Access Compliance Report

Public Rights-of-Way

(Curb Ramps)

Intersection ID: 10024504	Main Street: CRUMP_RD	Cross Street: N/A	Location: W
ADA ID: BEE4B5E7855A	Ramp Type: Perp	Initial Pass/Fail: Fail	Overall Compliance: No
			Severity Score: 21.25

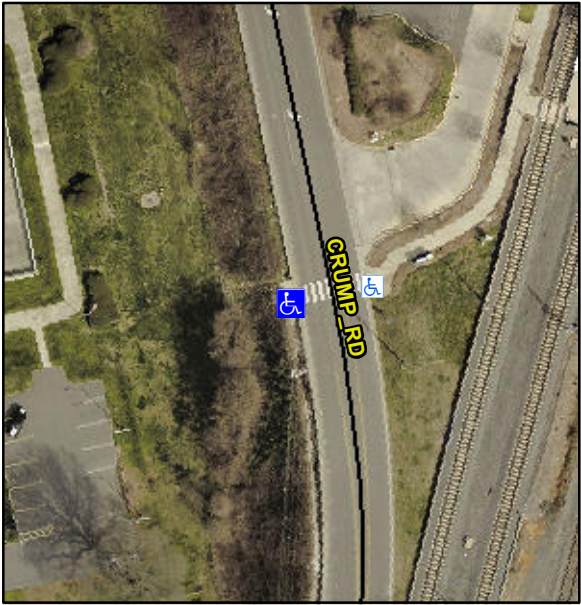
Codes/Mitigation Info/Possible Solution			Field Measurements/Component Compliance		
	Possible Solutions:		Compliance	Description	Data
	Remove & Replace Entire Ramp.		N/A	Ramp Length (in)	82.0
			No	Ramp Width (in)	46.5
			N/A	Flare Type LT	N/A
			N/A	Flare Slope LT (%)	N/A
			N/A	Flare Traversable LT?	N/A
			N/A	Landing Length (in)	N/A
			N/A	Landing Width (in)	N/A
			N/A	Landing Slope (%)	N/A
			N/A	Landing X Slope (%)	N/A
			N/A	Landing Curb? (Y/N)	N/A
			N/A	Shared Landing?	N/A
			N/A	Gutter Ponding?	N/A
			N/A	Gutter Lip Ht (in)	N/A
			N/A	Painted X Walk1?	Yes
				X Walk 1 Direction	To E
			N/A	X Walk 1 Width (in)	120.0
				X Walk 1 Slope (%)	1.4
				X Walk 1 X Slope (%)	0.7
			N/A	Ramp inside XWalk1?	Yes
<p>Surveyor Notes:</p> <p>N/A</p> <p>PROW/ADA:</p> <p>R304.5.1, R304.2.2</p>			N/A	Flare Type RT	N/A
			N/A	Flare Slope RT (%)	N/A
			N/A	Flare Traversable RT?	N/A
			N/A	DWS Provided?	N/A
			N/A	DWS Contrast?	N/A
